**SND Javelina Unit 9 16 P604
(503H, 604H, 605H, 504H,
606H) [fJMB2232160164]**

**C-144/ Permit Approval
with Conditions**

SND Javelina Unit 9 16 P604 (503H, 604H, 605H, 504H, 606H) [fJMB2232160164]
Temporary Pit non-low chloride fluids. Approval with Conditions.

NMOCD has reviewed [4323] CHEVRON USA INC, Application and Form C-144 received on November 16, 2022, for the proposed SND Javelina Unit 9 16 P604 (503H, 604H, 605H, 504H, 606H) [fJMB2232160164], Temporary Pit in Unit Letter A, Section 9, Township 24S, Range 31E, Eddy County, New Mexico.

Appendix D – Design Plan**SND Javelina Unit 9 16 P604 Pit****Temporary Pit**

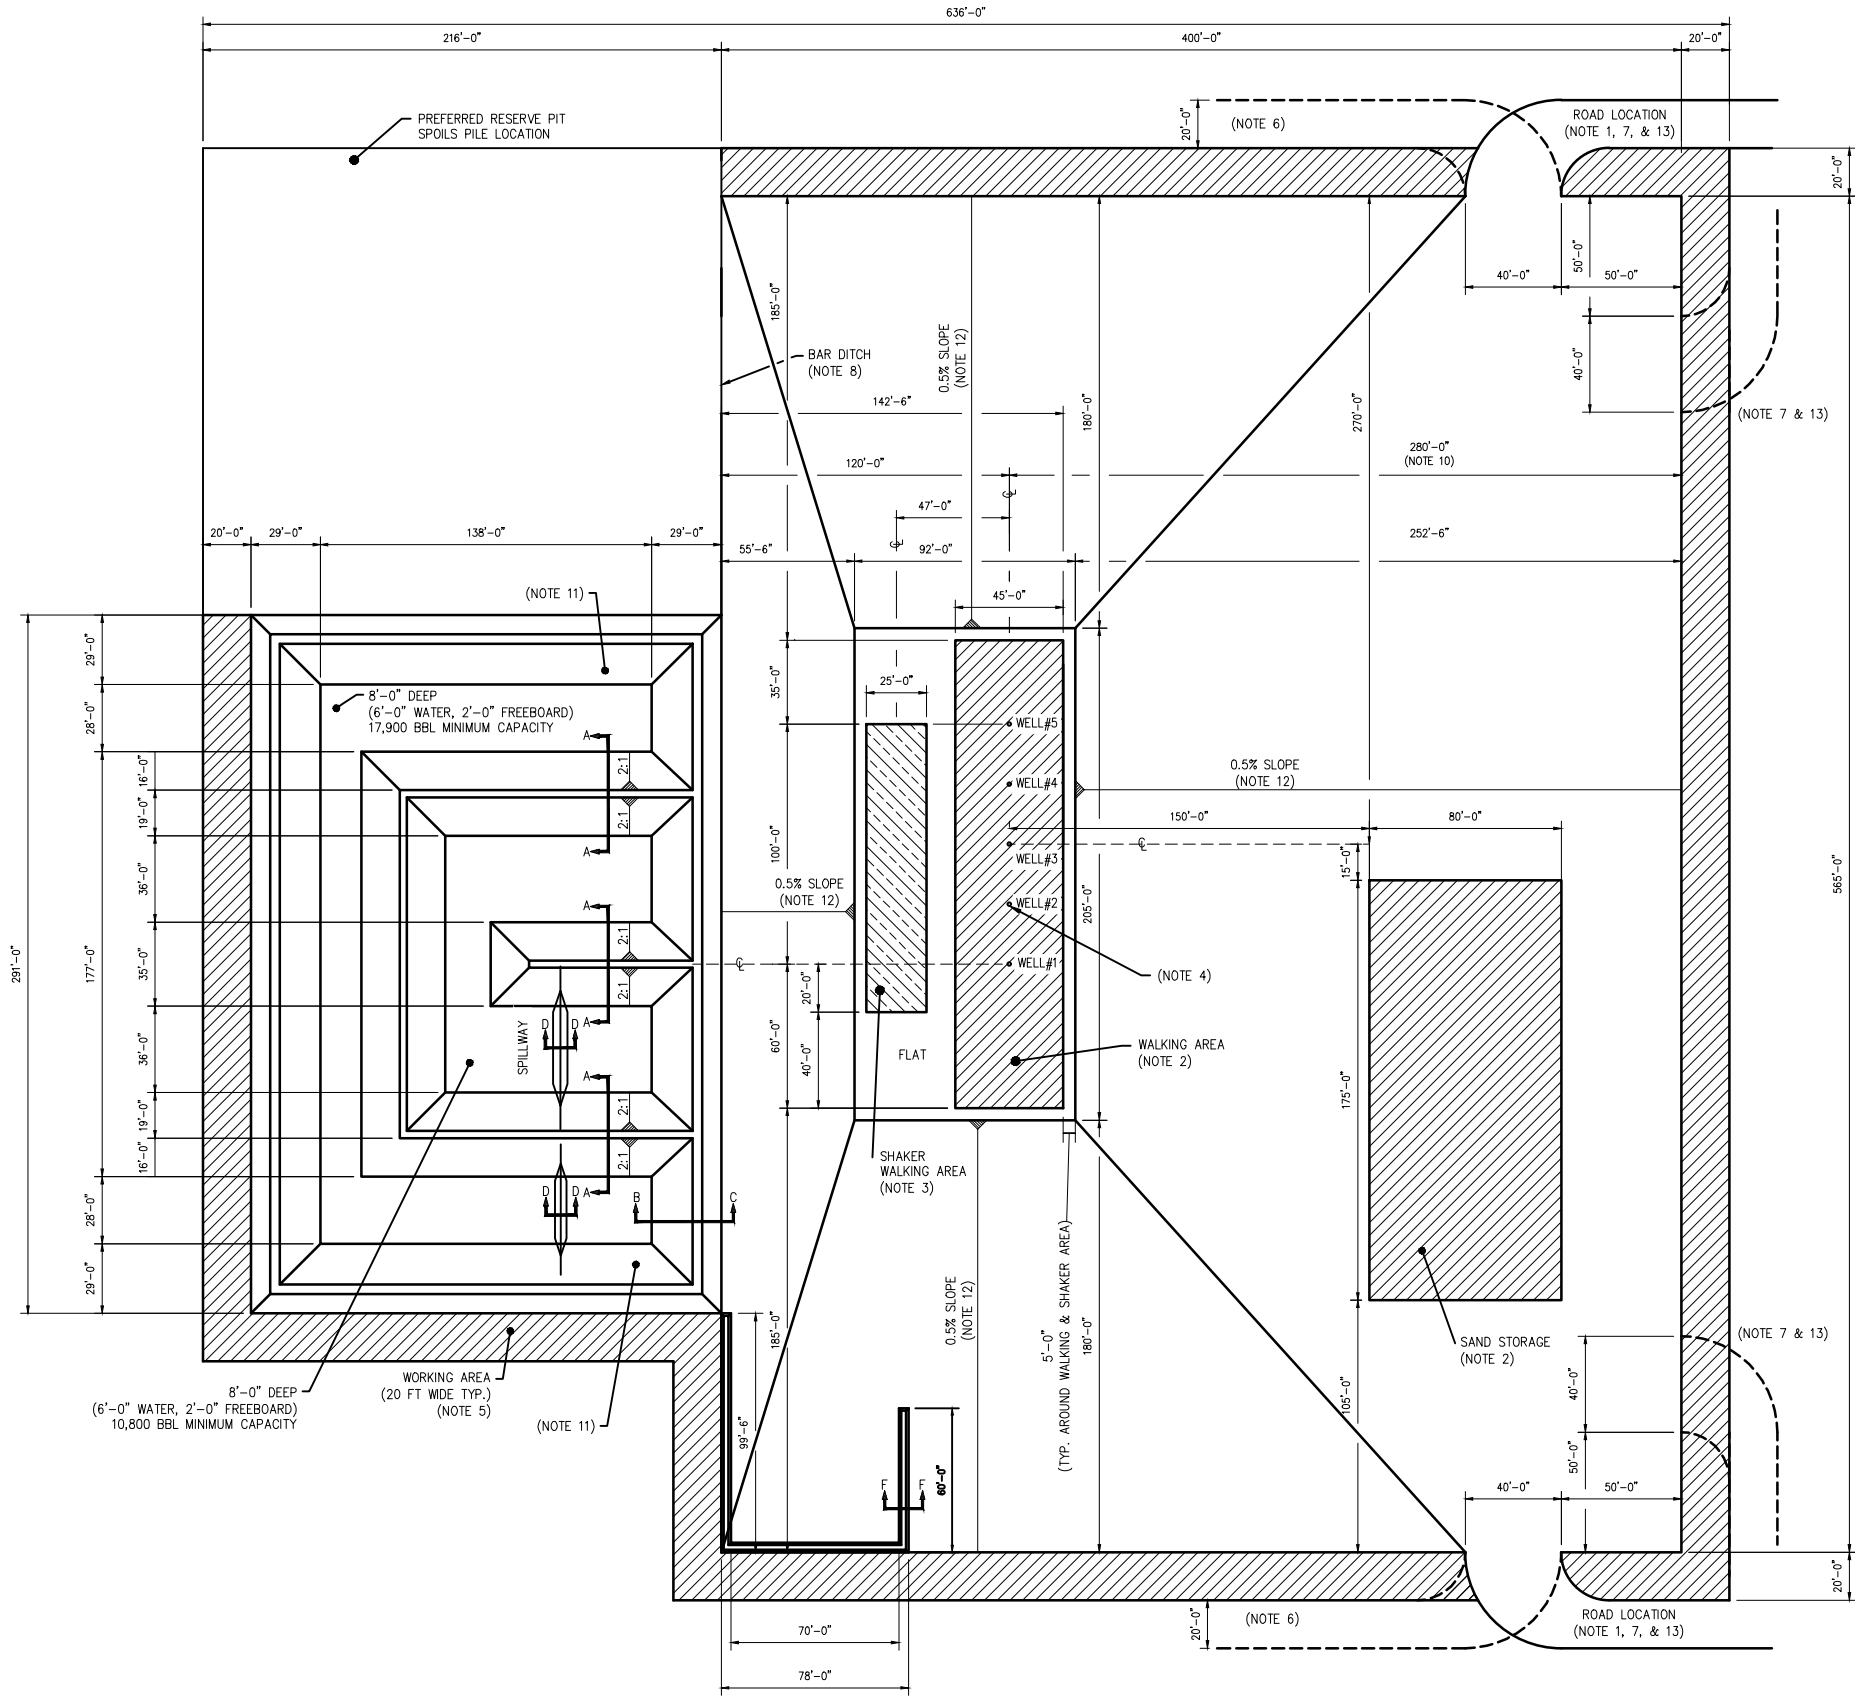
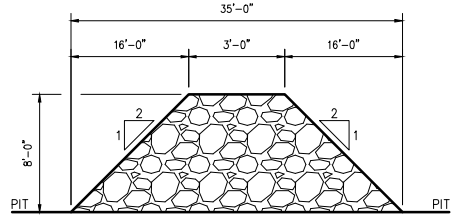
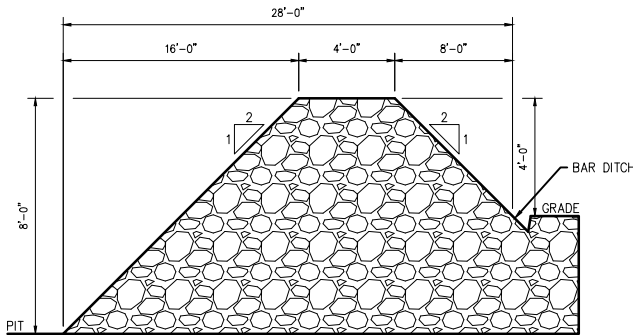
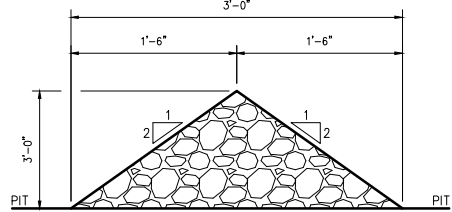
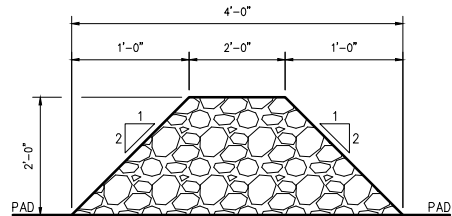
4. The design and construction plan, included as Appendix D of the Application, is approved. [4323] CHEVRON USA INC shall design and construct SND Javelina Unit 9 16 P604 (503H, 604H, 605H, 504H, 606H) [fJMB2232160164] Pit as described in the approved plan. [4323] CHEVRON USA INC shall apply for a permit modification for any change to the plan.
